**REFERENCE:** 16/3/3/1/D1/13/0001/25

**COMMENT ON THE DRAFT BASIC ASSESSMENT REPORT FOR THE PROPOSED RESIDENTIAL DEVELOPMENT ON PORTION 91 OF THE FARM MATJES FONTEIN NO. 304, KEURBOOMSTRAND**

**RE: REQUEST FOR COMMENT FROM THE SUB-DIRECTORATE: COASTAL MANAGEMENT ON THE DRAFT BASIC ASSESSMENT FOR THE PROPOSED RESIDENTIAL DEVELOPMENT ON PORTION 91 OF FARM MATJIESFONTEIN 304, KEURBOOMSTRAND, PLETTENBERG BAY, WESTERN CAPE.**

**COMMENT ON DRAFT BASIC ASSESSMENT REPORT IN TERMS OF THE NEMA ENVIRONMENTAL IMPACT ASSESSMENT REGULATIONS FOR THE PROPOSED DEEVELOPMENT ON PORTION 91 OF THE FARM MATJESFONTEIN NO. 304, KEURBOOMSTRAND, BITOU MUNICIPALITY**

Figure 2: Alternative 2 indication 19 erven in line with KELASP

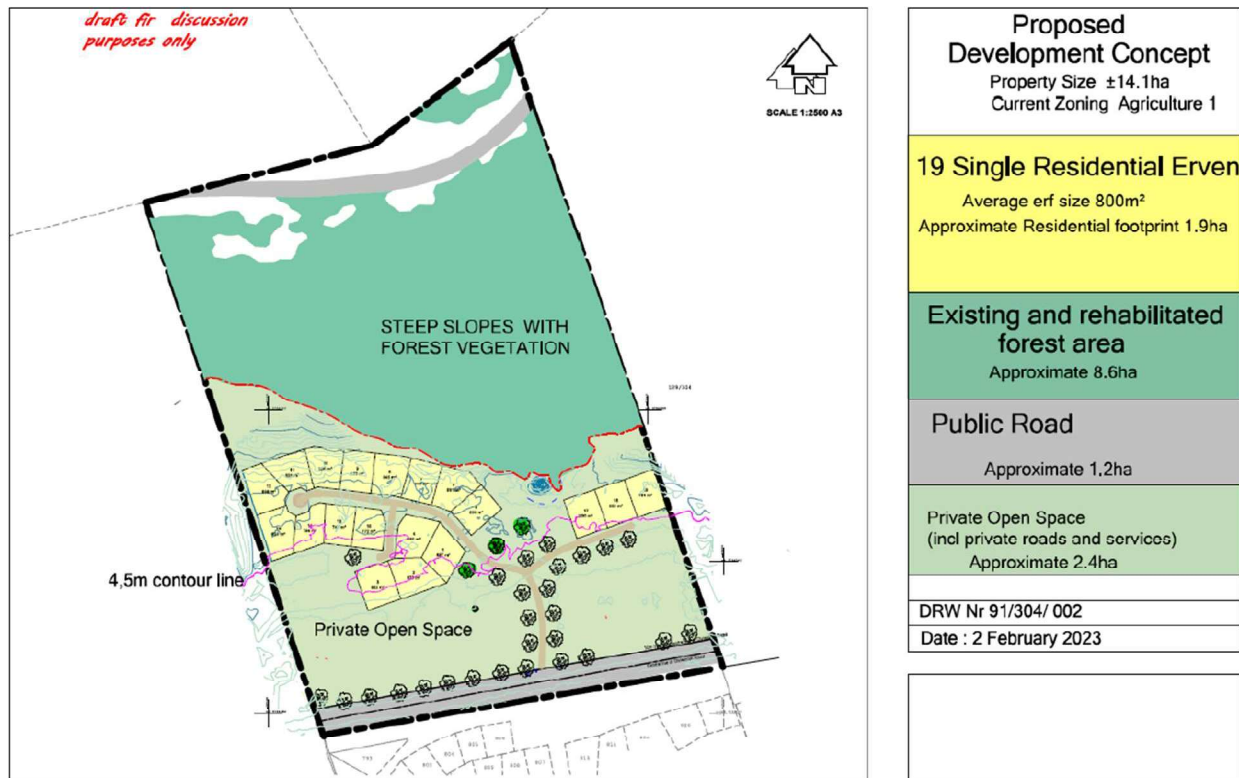
The question arises; Why was Alternative 2 in the Draft BAR not further investigated? The only reason provided is that the low density was not financially viable. Alternative 2 (Figure 2 below) with the proposed 19 erven is in line with the KELASP, as per Figure 1. Alternative 2 can be a much better alternative to reinstate the natural environment and not only complement the sense of place but also create a development where humans, fauna and flora co-exist.

Figure 4: Ground floor plan of a proposed dwelling unit

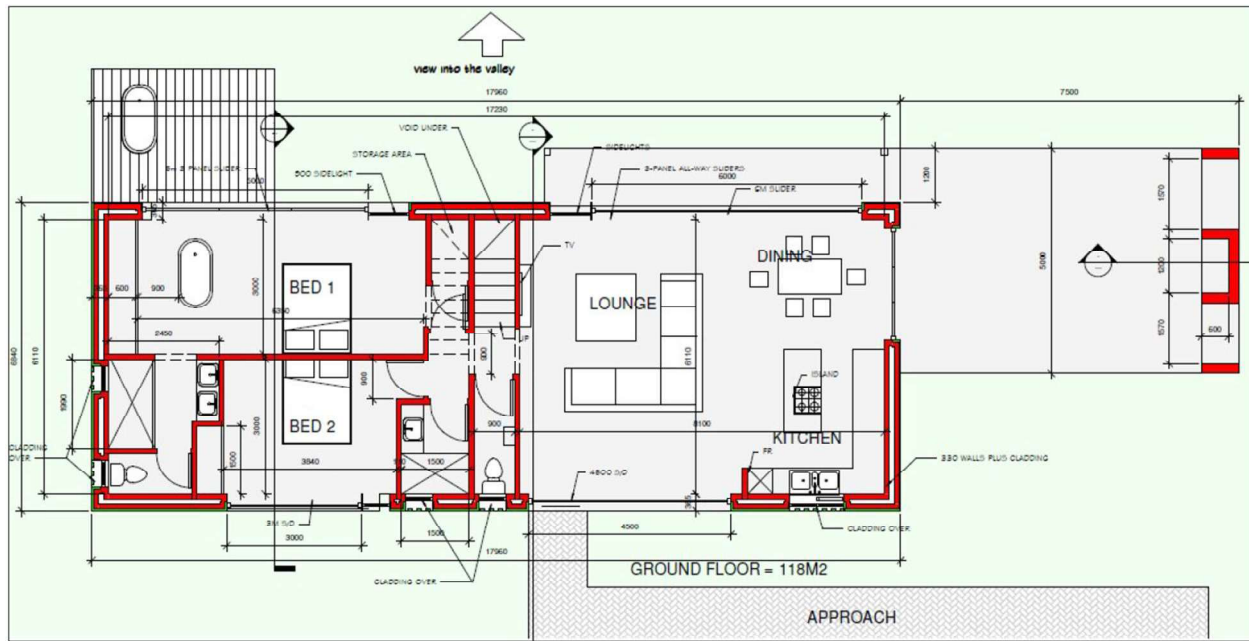
The proposed dwelling unit as indicated in *Figure 4* will have a footprint of  $122,8\text{m}^2$  ( $17,960 \times 6,840$ ). Multiply by 2 for a double storey unit (the stairs in the drawing indicated that there is another floor) thus a total floor area of  $245,6\text{m}^2$ . The braai-area is another  $37\text{m}^2$  which brings the approximate unit size to  $282,5\text{m}^2$  - this excludes the patio and walkway from the lounge to the braai-area. The floor plan provided does not indicate any provision for parking by means of a carport or motor vehicle garage. The style and size of the proposed unit one could assume that a double motor vehicle garage (2 vehicles) will be provided (visible on *Figure 5* below), with a standard size of  $36\text{m}^2$ . If the dwelling units will include a motor vehicle garage, the total size would be approximately  $320\text{m}^2$ . Although the dwelling unit size of the proposed development and the existing Milkwood Glen is similar, the amount of greenspace and mature trees in Milkwood Glen provide a serene environment with the sense of place where humans and nature co-exist.

*Fig.10: Topographical cross-sectional plans A to A' as per Fig.9 . Beacon Survey June 2024 and VPM Survey 2023.*

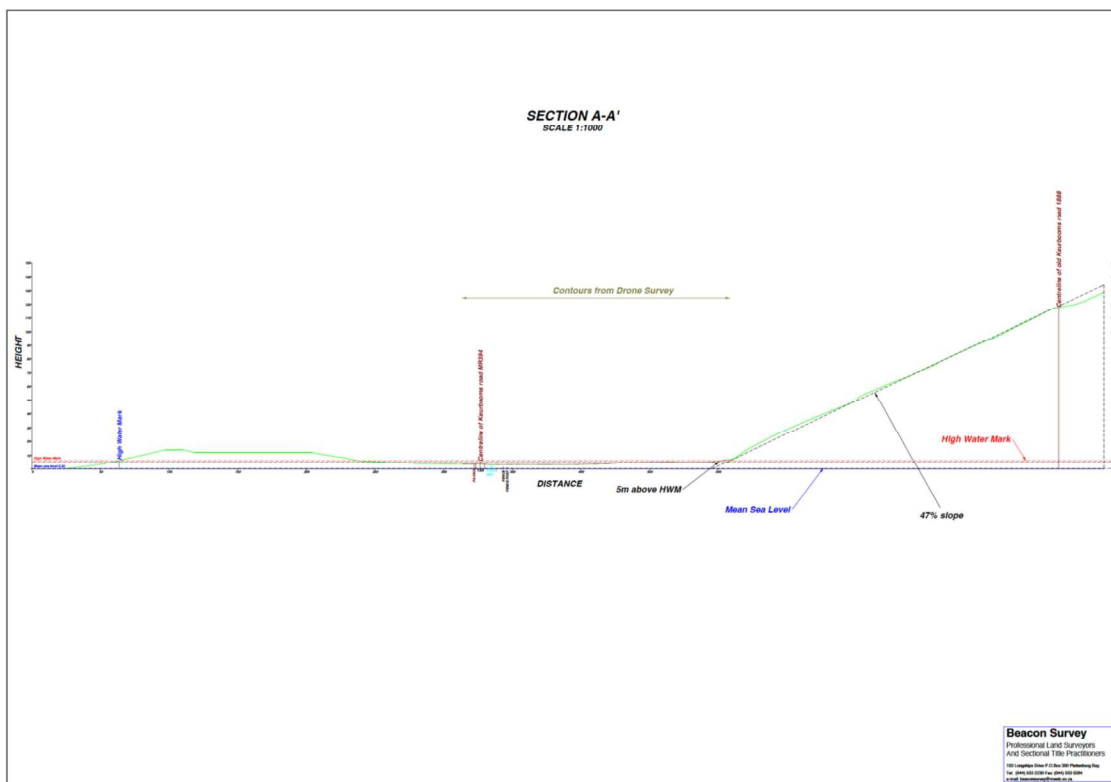
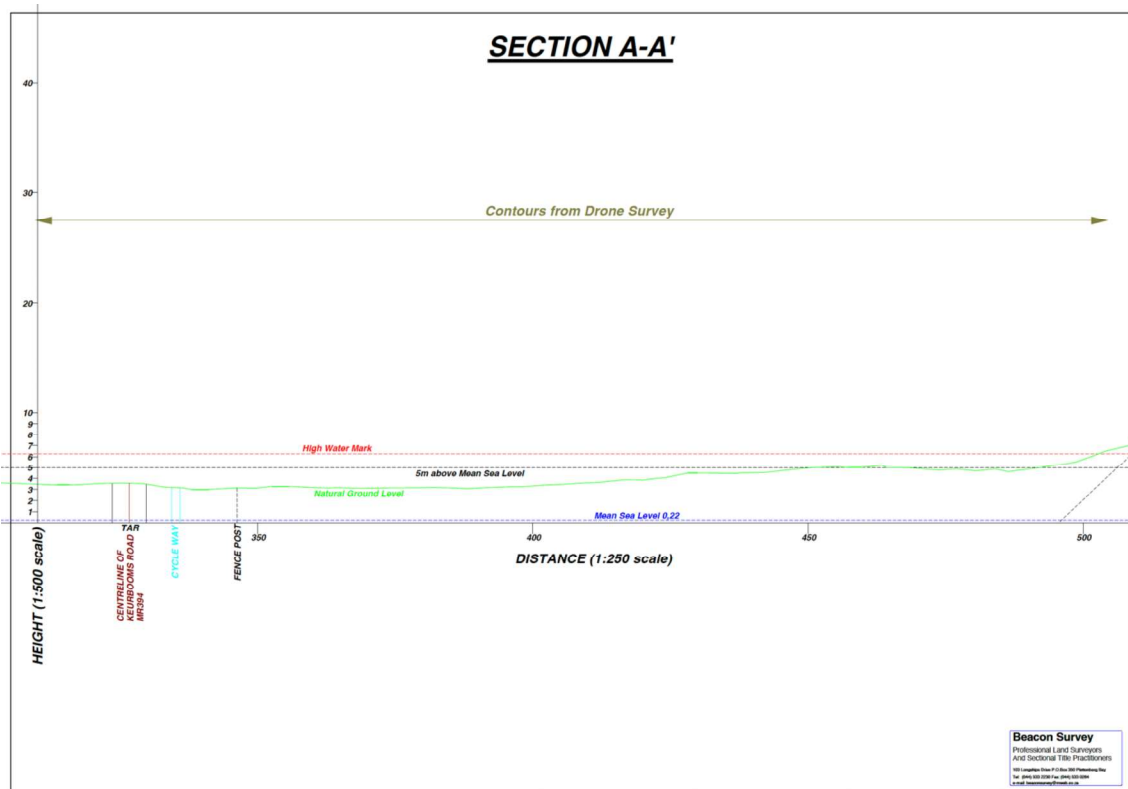
All of the above mentioned sites ie 1), 2) and 3), are situated in the Keurbooms-Bitou Estuarine Functional Zone, a flood plain, which is less than 5m above mean sea-level.

Fig.12: Keurbooms Estuary: Estuarine Management Plan showing 1 in 50 and 1 in 100 flood lines.

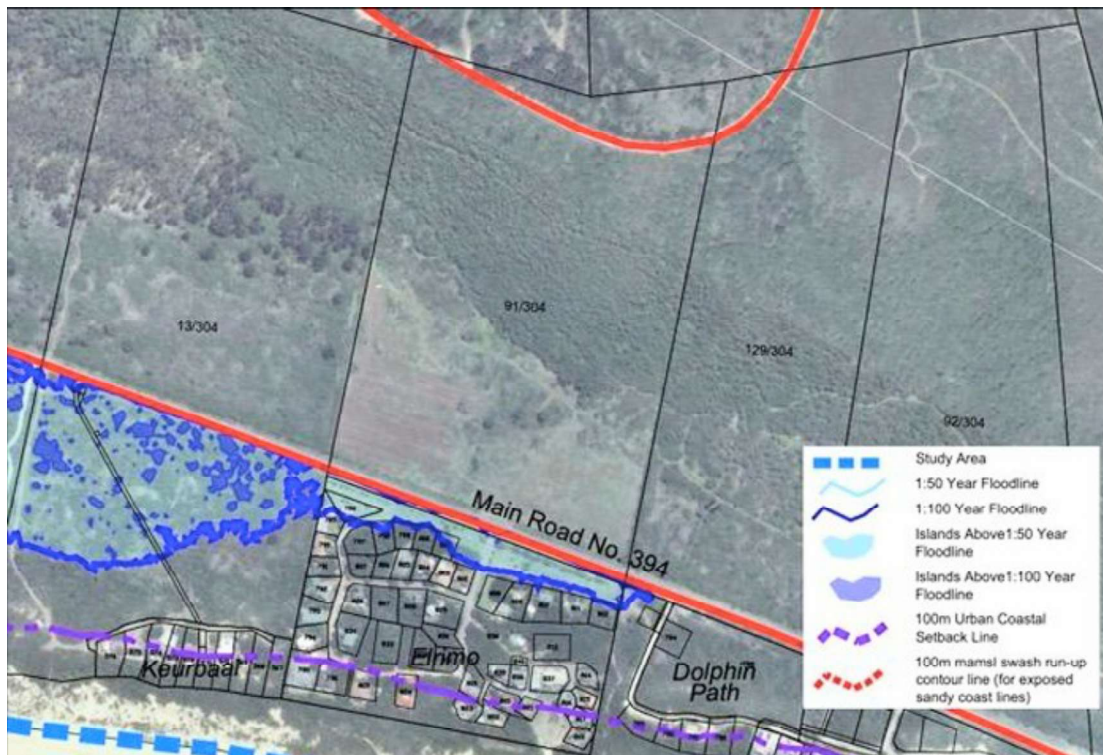
I would strongly agree that the 1 in 100 year flood line, should therefore be reviewed, as per the recommendations of the Garden Route District Climate Change Adaptation Response Implementation Plan (2024).

Figure 2 Cross-section through part of the proposed development site (south is on the left, north on the right).

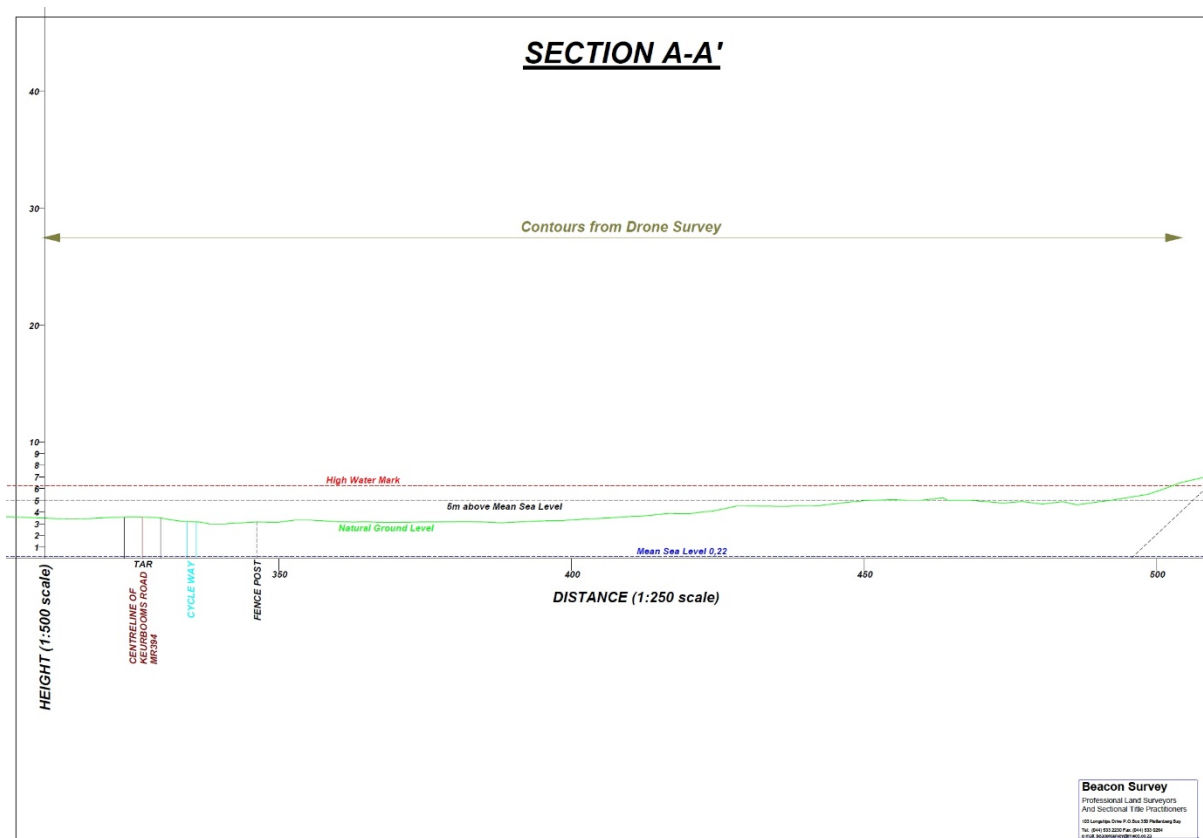
The cross-section data suggests that almost all parts of the development will be below 5m above mean sea level (the black dashed line in Figure 2). There seems to be little doubt that the site does play a role in providing some flood storage, as well as the fact that the site is highly likely to be flooded during heavy and prolonged rainfall events.

**Figure 2D: SEWAGE DEMAND: LEVEL CLEARED AREA OF PROPOSED DEVELOPMENT**

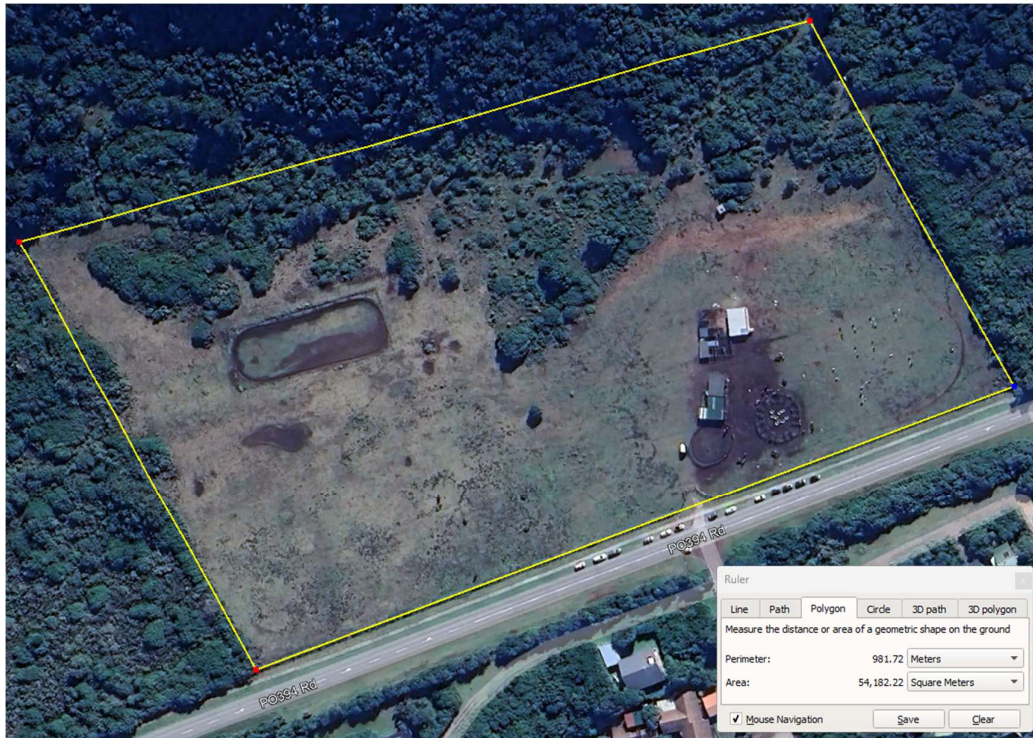
The developer proposed to dispose of the treated wastewater on site by means of irrigation and other. The volume treated wastewater will be from rough estimated calculations be in the order of 36000 litres per day. Now to put this volume of water in perspective the following:  
 Area of development is approximately 54182 m<sup>2</sup> (level cleared area of site as per Figure 2D).  
 Now irrigation area is assumed to be 30% x 54182 m<sup>2</sup> (70% is buildings and roads and retention ponds and other) equals to 16255 m<sup>2</sup> (irrigation area).

Figure 3B: STORMWATER: SECTION A-A

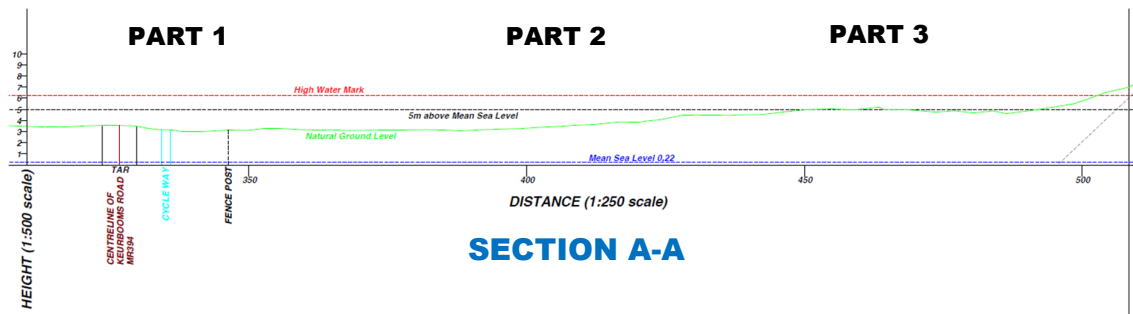
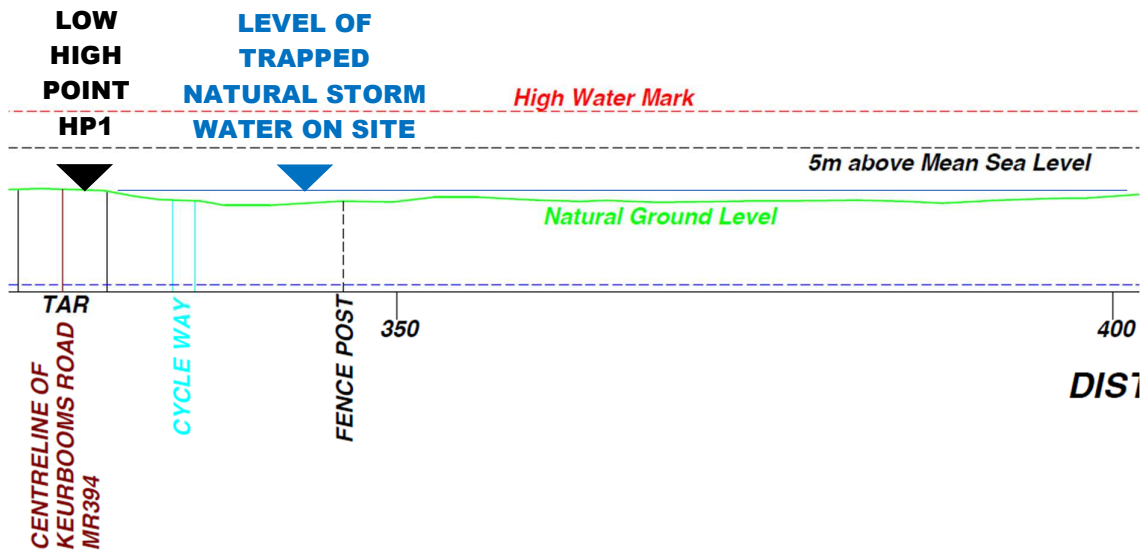
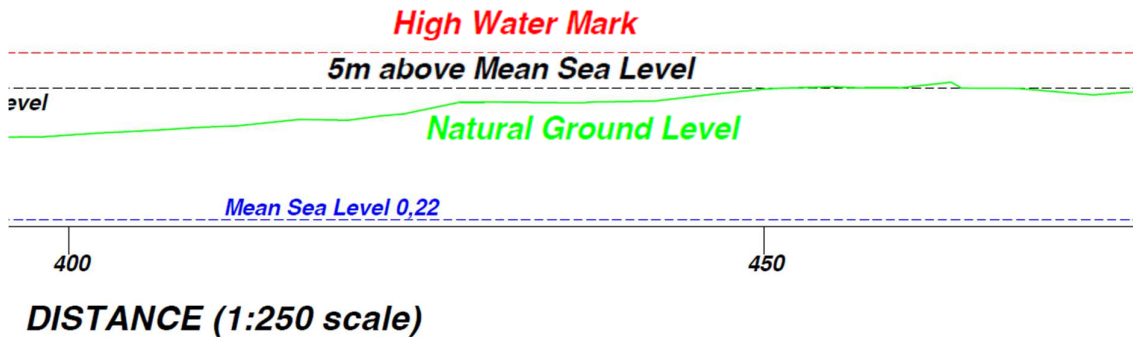
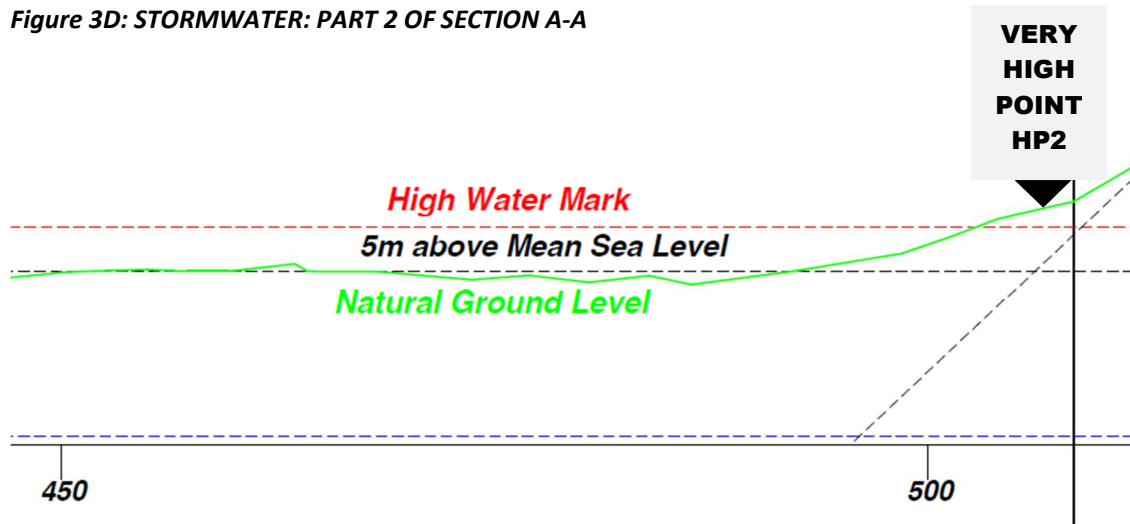
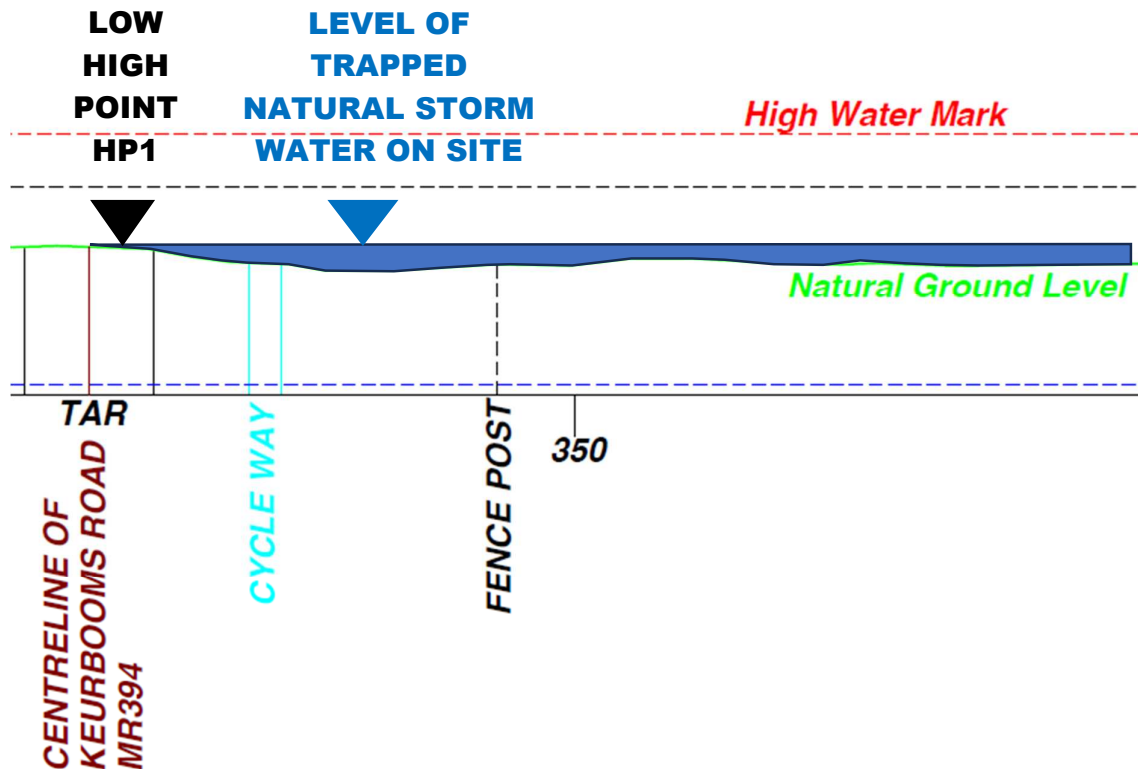
The land locked site with the trapped stormwater between the high points is illustrated below with the enlarged Section A-A part 1, part 2 and part 3.
